Design Revision 01

eProjects Work Order Number: 1637041
Construction Contract Number: N40085-25-R-2611
Buildings: CEP 200 & CEP 209
Project Title: CEP 200 & 209 Office Renovations
Date: 25 April 2025

Design Revision Purpose

1. Response to PPIs

A1 BLDG CEP-209 - PARTIAL TELECOMMUNICATIONS PLAN - DEMOLITION
1/8" = 1'-0"

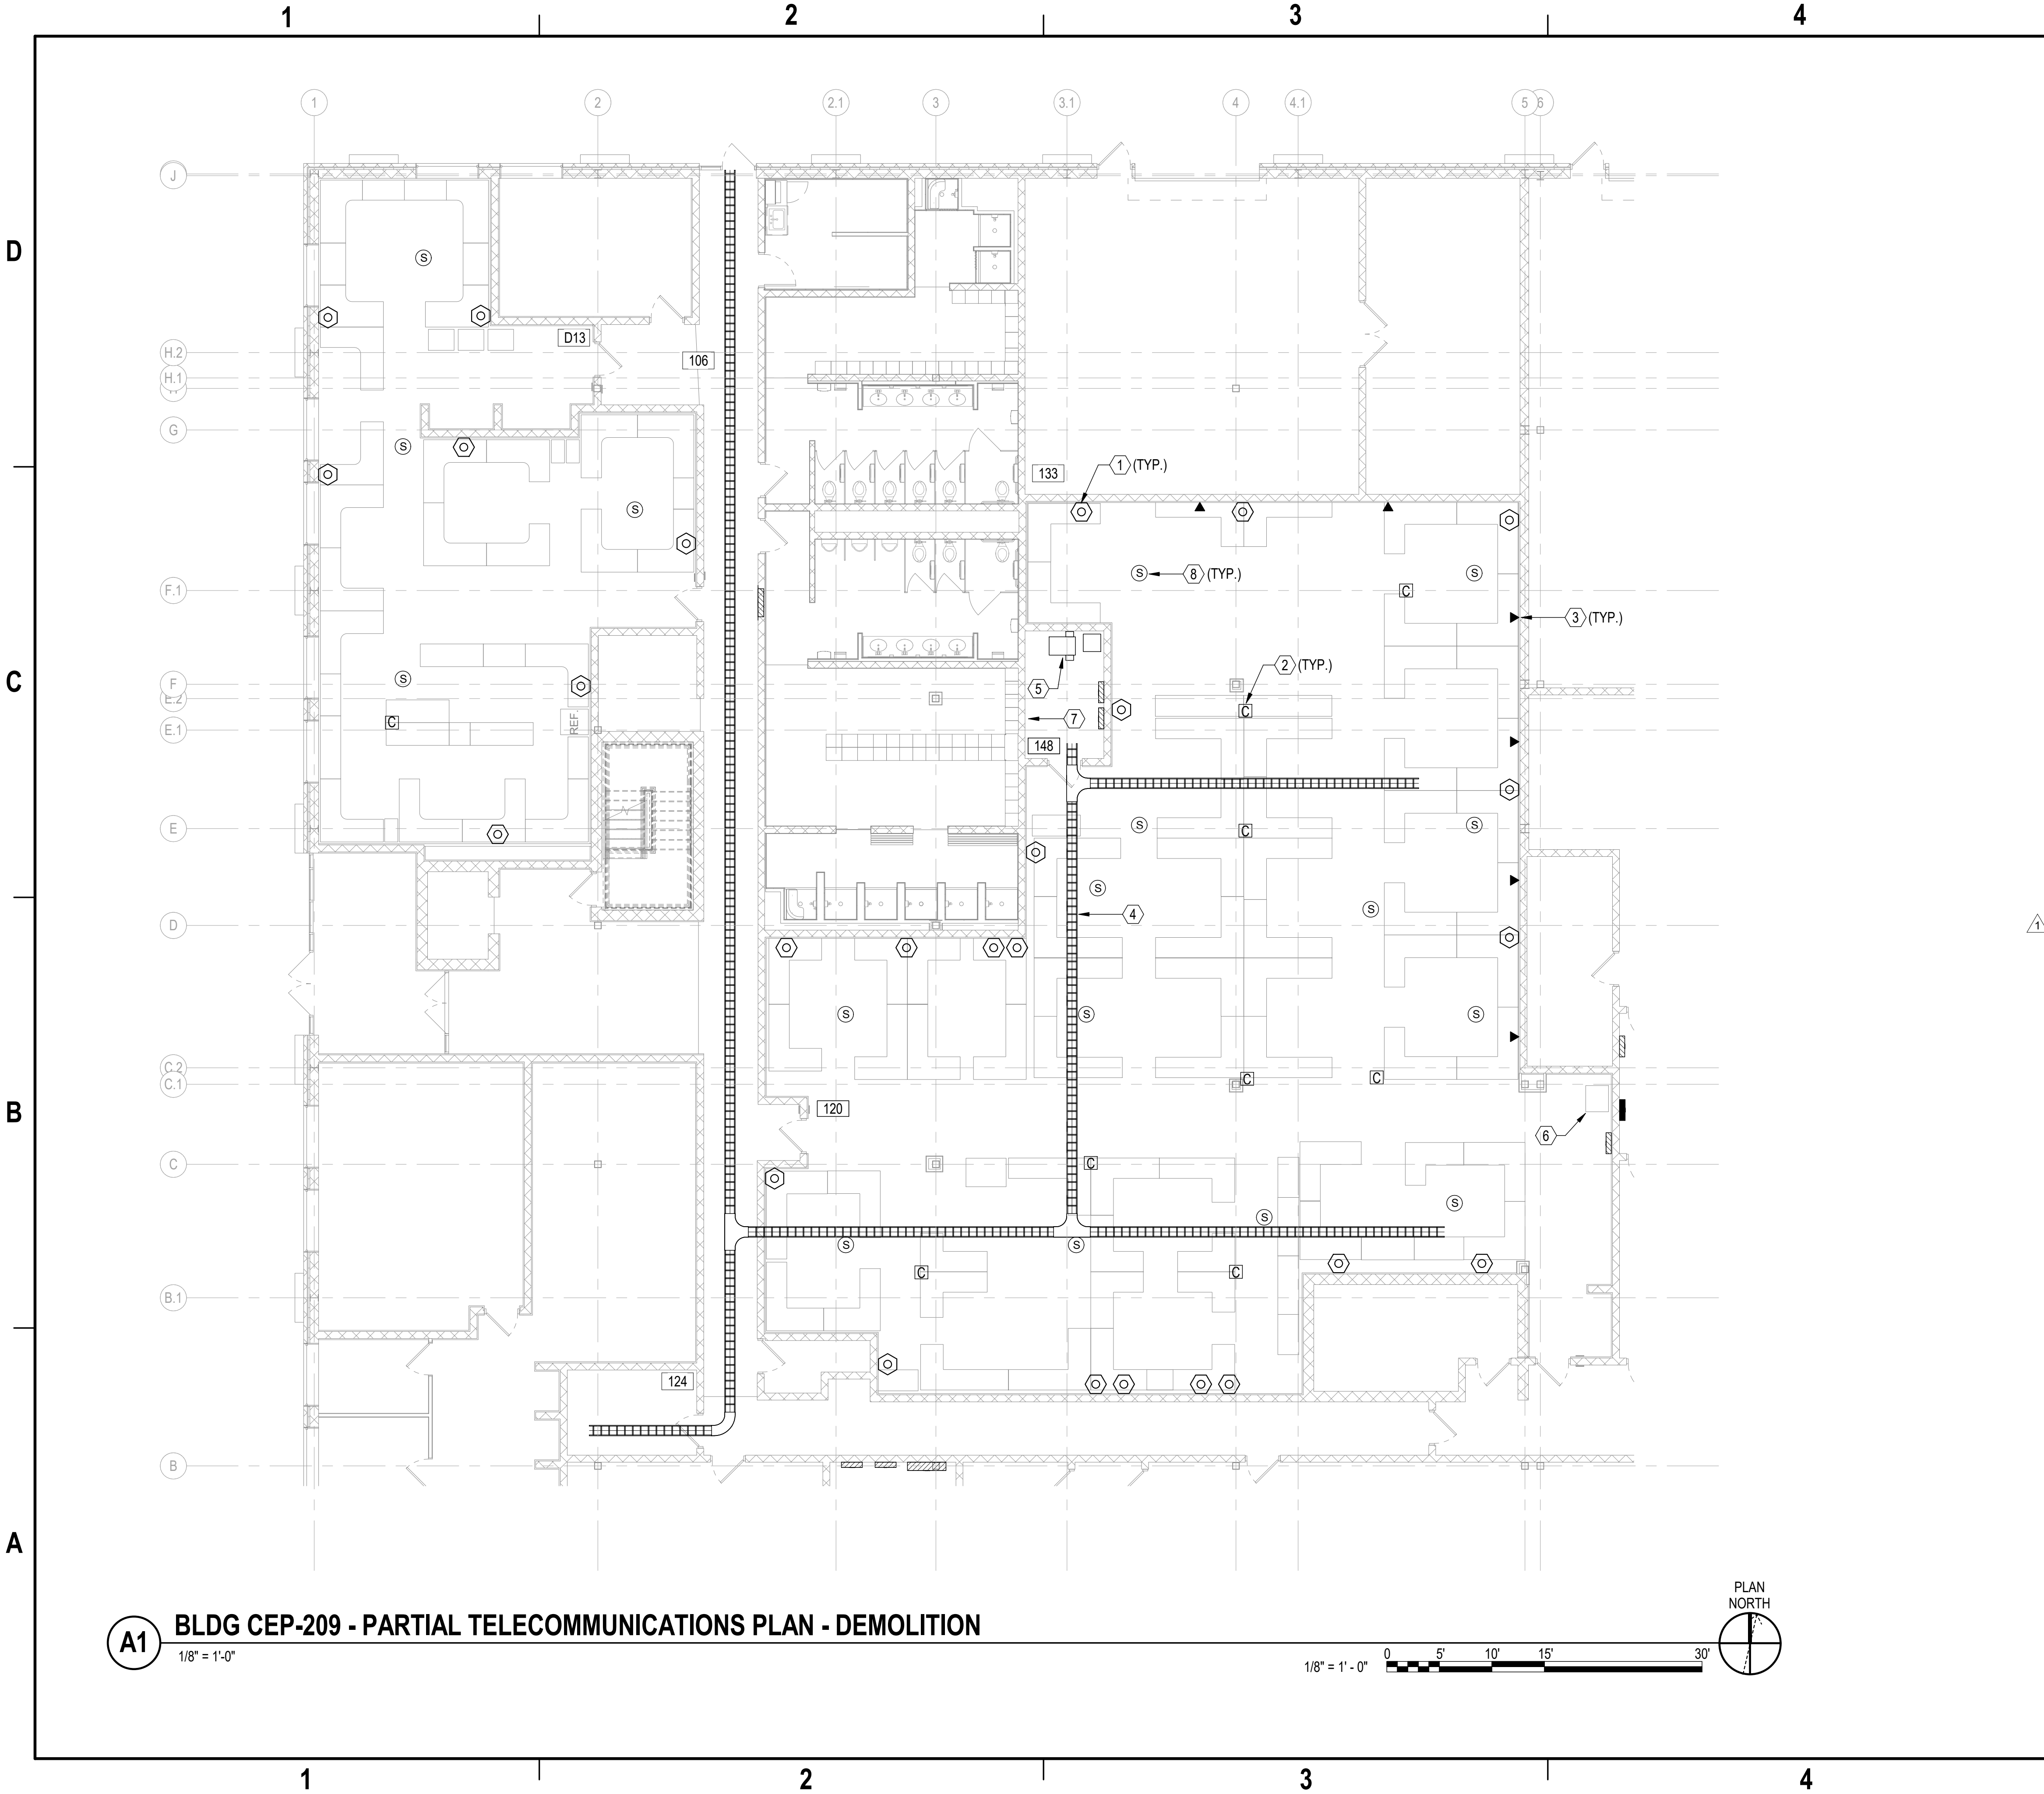
Keynotes: Keynote 1 changed to “Disconnect existing systems furniture telecommunications connection from systems furniture. Demolish data telephone cabling back to source. Demolish associated surface raceway and conduit back to nearest upstream junction box.”

Keynote 2 changed to “Disconnect and demolish existing power pole for systems furniture and data and telephone cabling back to source.”
